UNITED STATES PATENT AND TRADEMARK OFFICE

Office Action Summary**Application No.**

10/595,657

DETAILED ACTION

Figure 3 (Rider, Jr. et al.)

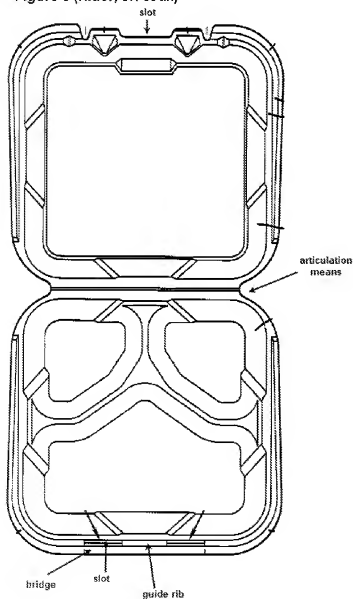
11. Regarding Claim 6, Rider, Jr. et al. discloses a connection means which comprises a male element 38/40 (Figure 3) integral with one half-shell and having a generally anchor-like configuration with resilient anchoring ends (Figure 6 below), and a female element 42/44 (Figure 1) formed by a bridge-like wall (Figure 3 below) defining an open-ended slot (Figure 3 below) in which the male element can be inserted, and in which the anchoring ends can engage the walls delimiting the slot (Figure 7).

12. Regarding Claim 7, Rider, Jr. et al. discloses a male element which comprises a pair of substantially parallel, resilient prongs 38/40 (Figure 3) separated by a slot (Figure

3 below), wherein the female element comprises a guide rib (Figure 3 below) which can be inserted in the slot between the prongs, and wherein the female element comprises projecting engagement means (Figure 6 below) which can cooperate with the anchoring ends of the prongs to prevent removal of the male element from the female element (Figure 7).
